Concord Middle School Project

Project Manager Report

August 2021

To: Court Booth, Chair CMS Design Subcommittee
 From: Kristen Olsen, SMMA
 Project: Concord Middle School Project
 Re: Design Subcommittee Decisions
 Distribution: (MF)

WINDOW OPTION COMPARISON

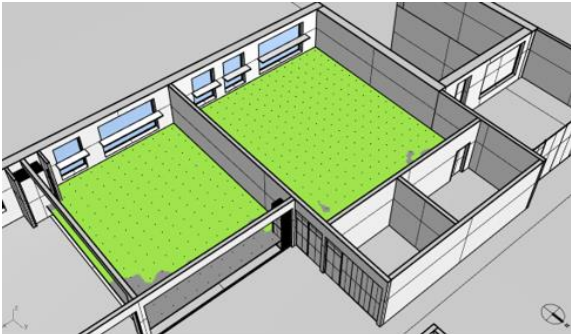
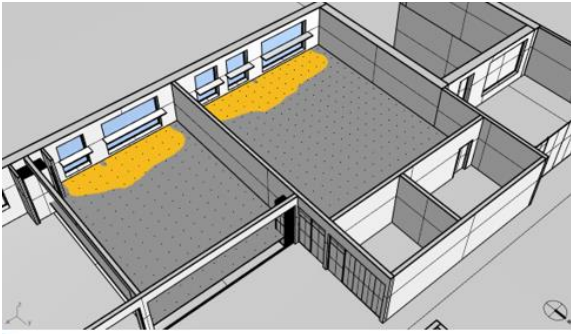
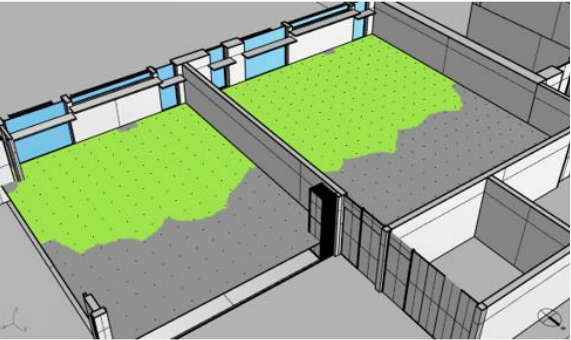
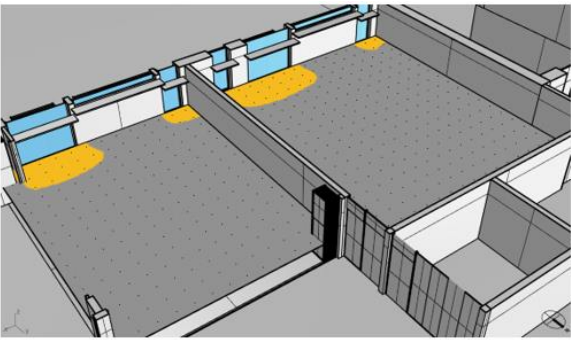
- Matt Johnson noted having a preference to have the middle row of windows aligned instead of mirroring between floors 1 and 3. He furthermore noted the color choice of grey does not reflect local materials and therefore, does not have a naturalistic look and feel.

- Dawn Guarriello suggested to the design team to look at interior light shelves that could bounce the light farther into the room.
- Heather Bout noted the classrooms could have more daylight and expressed concern with the whiteboard being on the same wall as the windows. For the exterior, having the façade blend with the surrounding environment is preferred.

The Subcommittee and the design team examined window configurations, daylight and glare analysis, and wall-to-window ratio. "Option 1," a two-window classroom approach, was deemed better than Option 3 (3-window and whiteboard on exterior wall). Spatial daylight autonomy (sDA) and annual sunlight exposure (ASE) calculations for a school year were shared (slide 12), with both 24" deep exterior sunshades and 18" interior light shelves on the south side providing the best results.

Building Skin

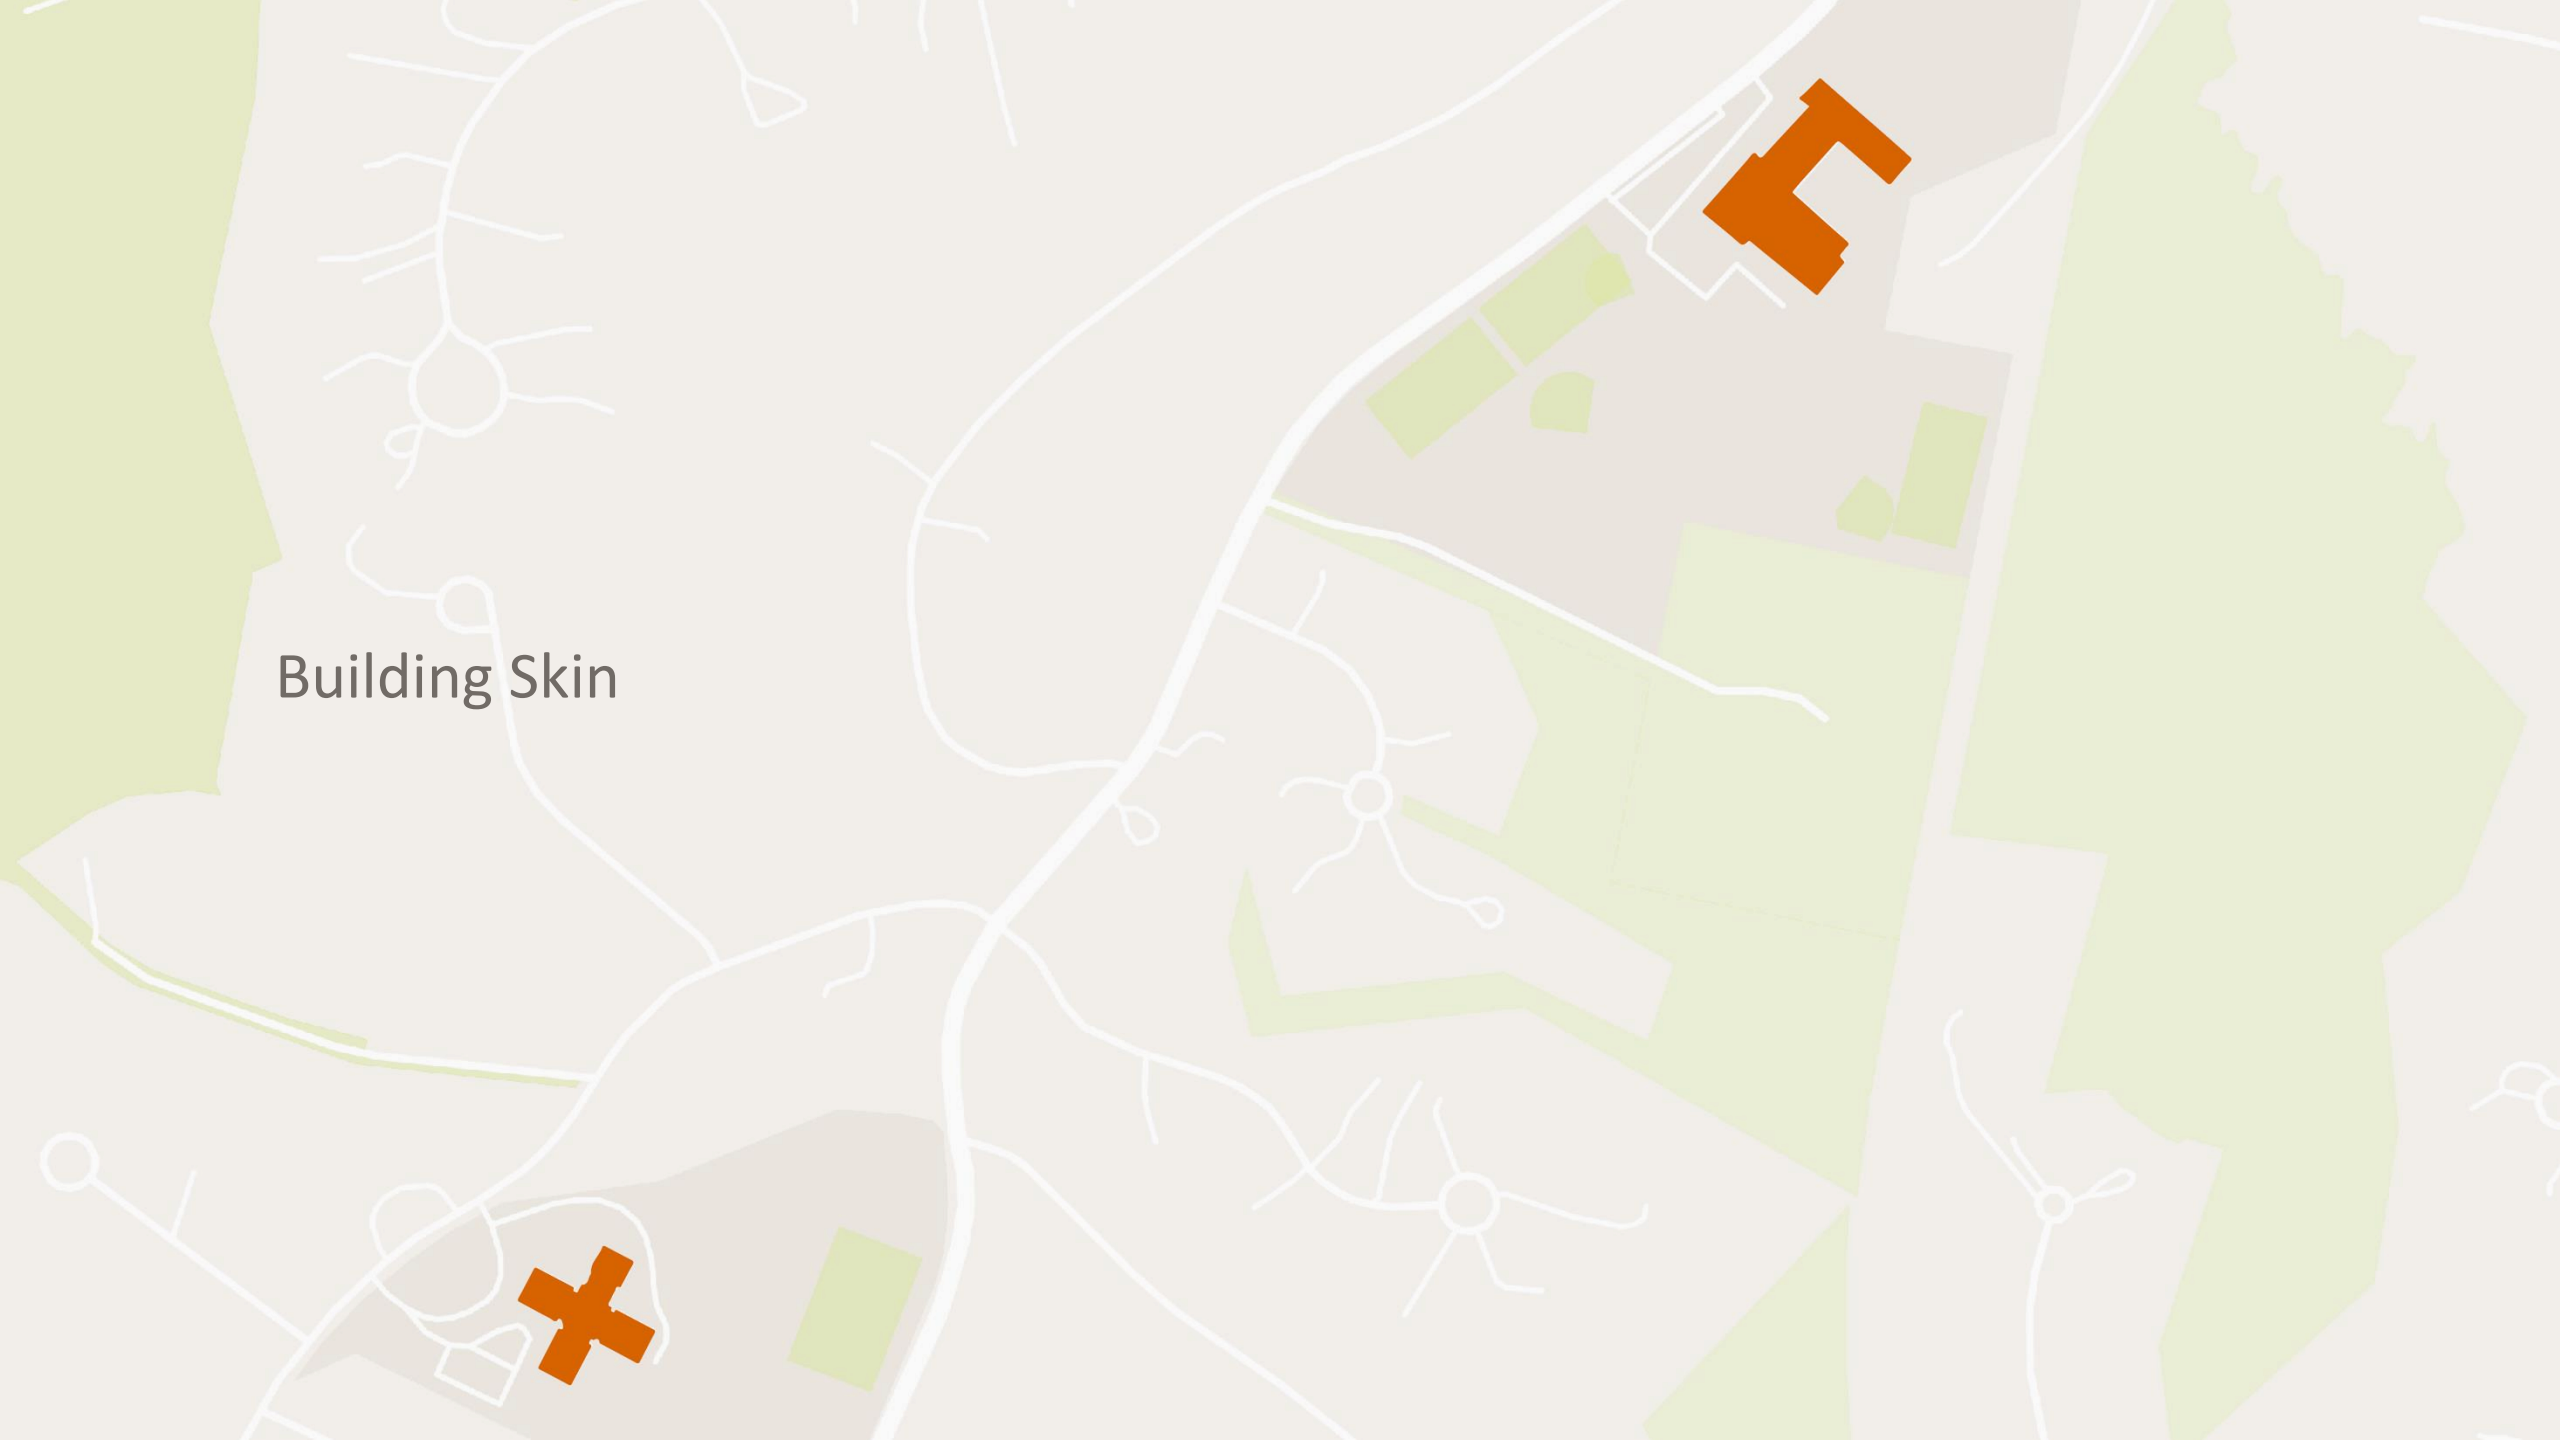
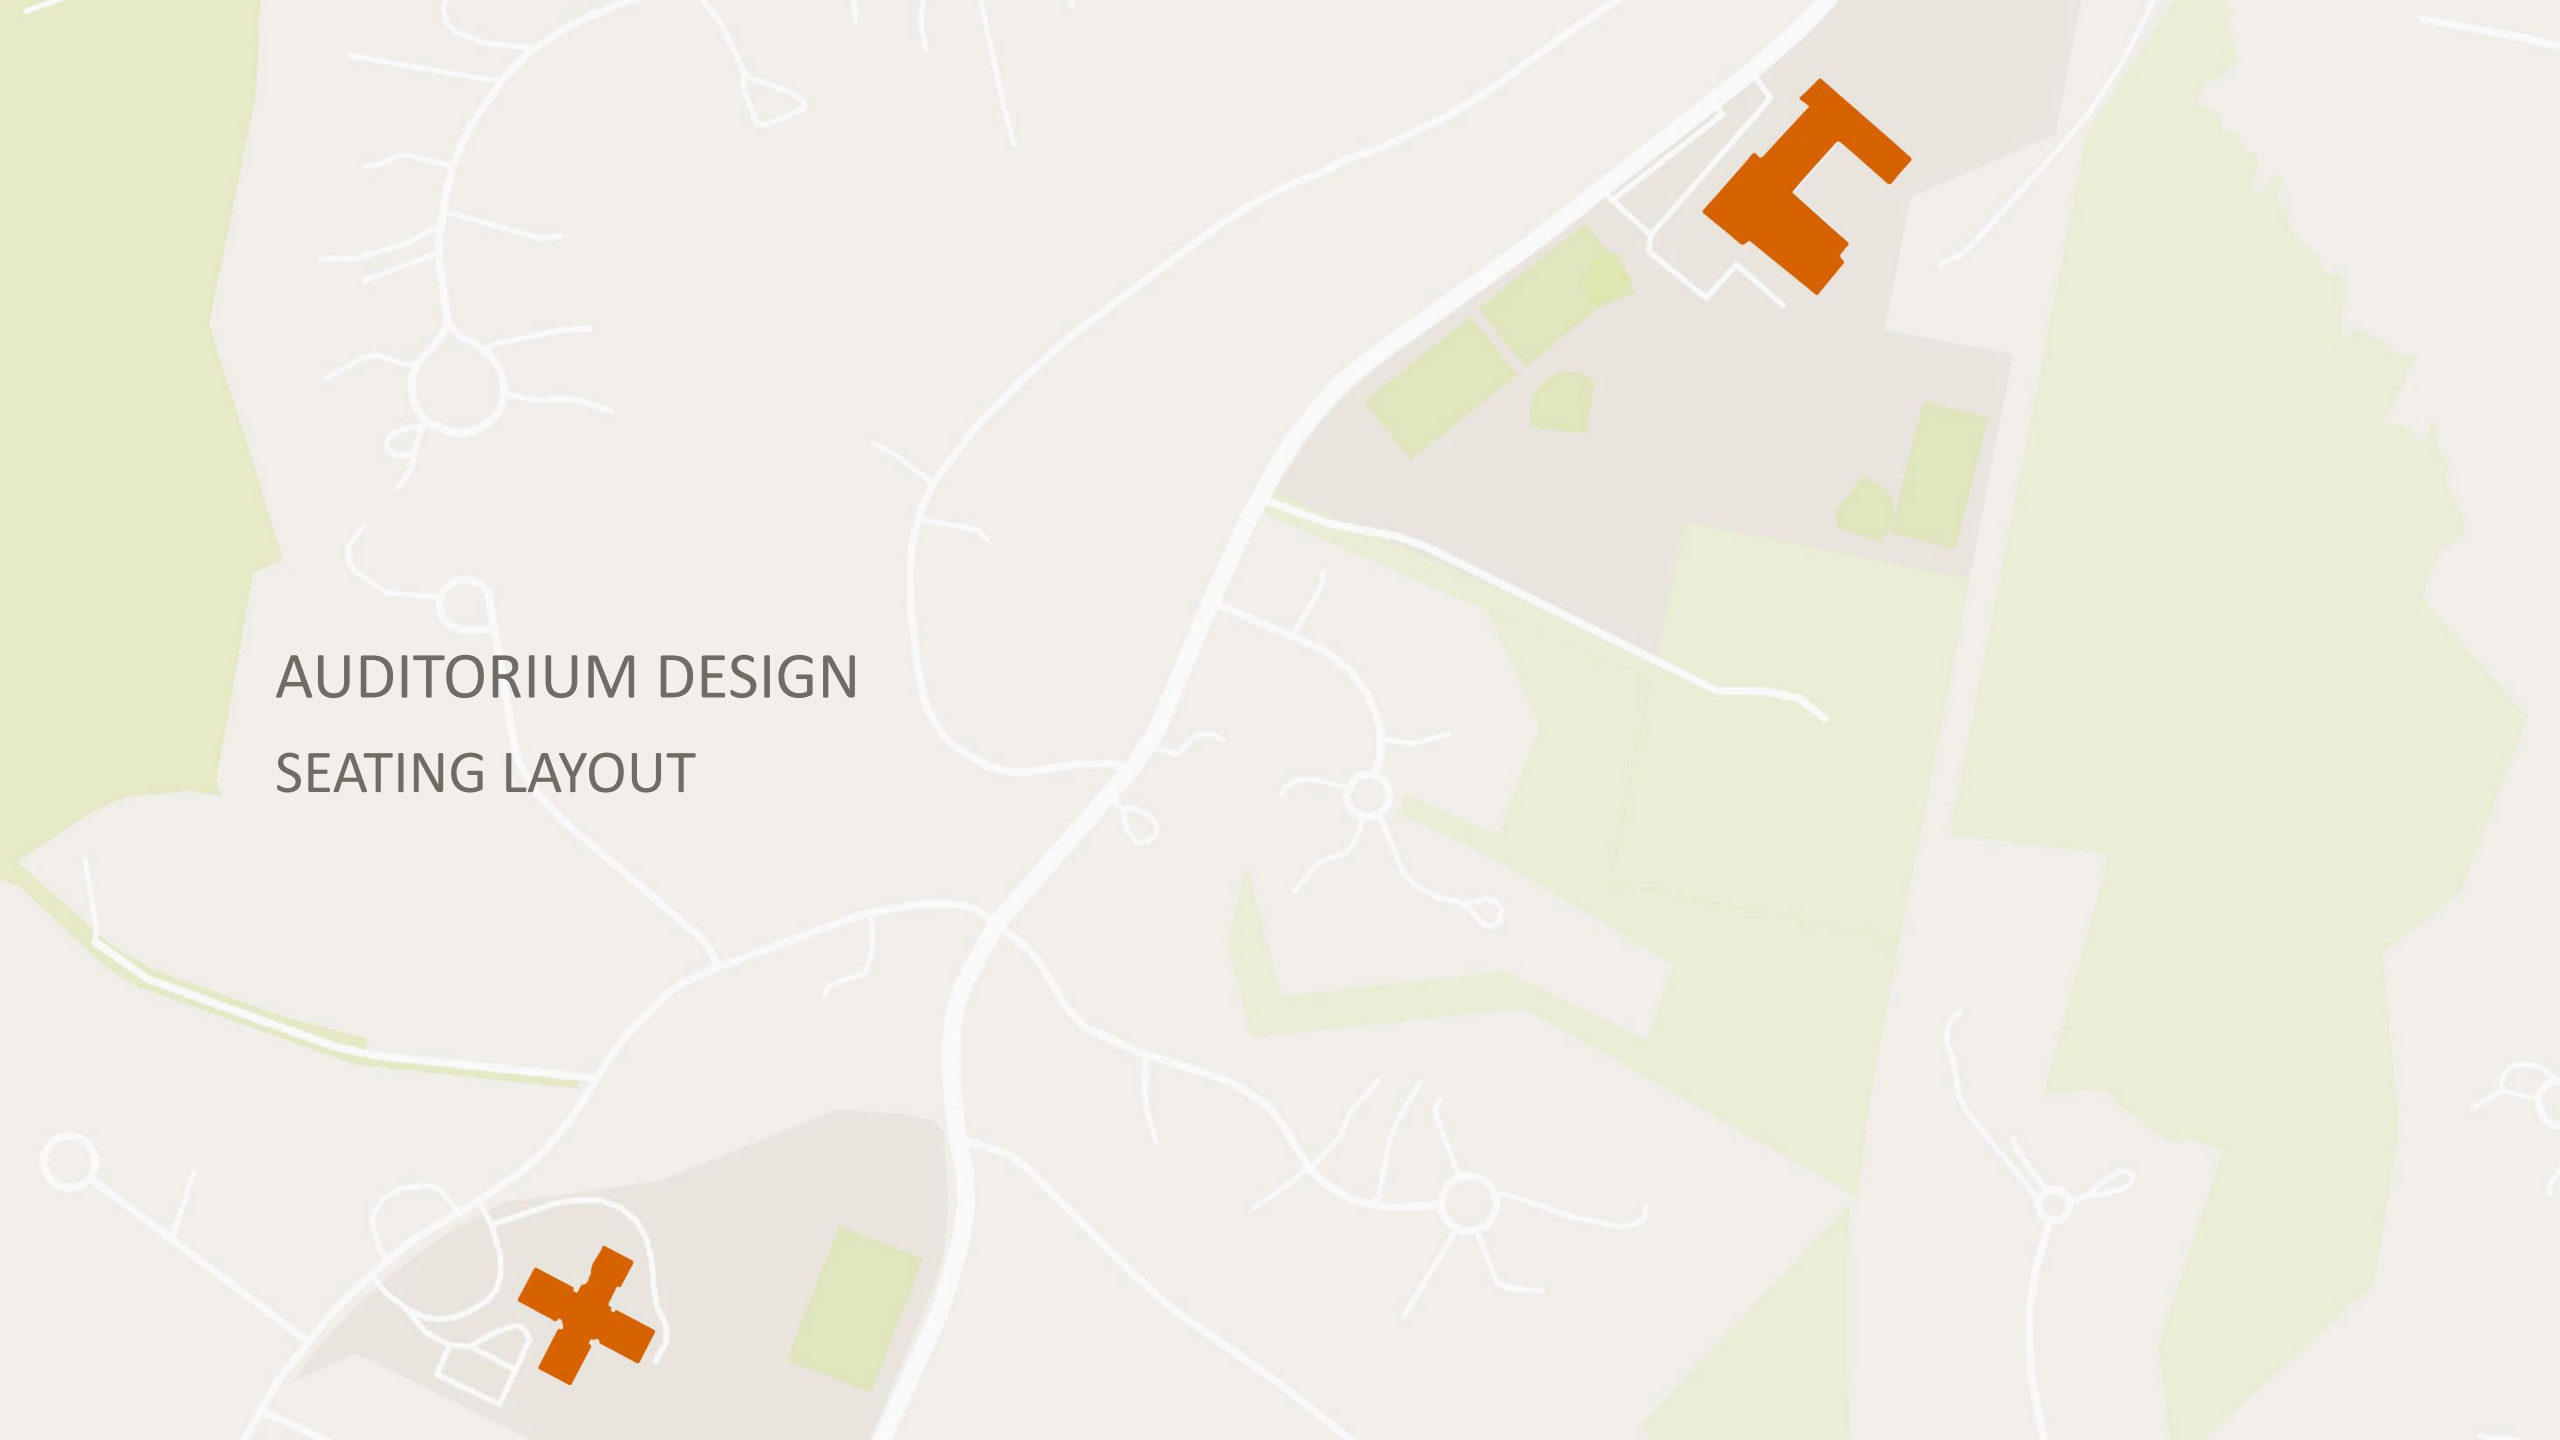
The Subcommittee and the design team examined building skin alternatives (slide 15) and weighed the merits of those presented. #2, a traditional brick color and pattern, was eliminated. #3, "grain," was the first choice of two members, second choice for 3 members, placing it in the preferred category. More color choices in the grain pattern will be examined at a future meeting. #4, "texture," was the second most preferred, with debate about the ½" sections of brick protruding (the texture appearance).
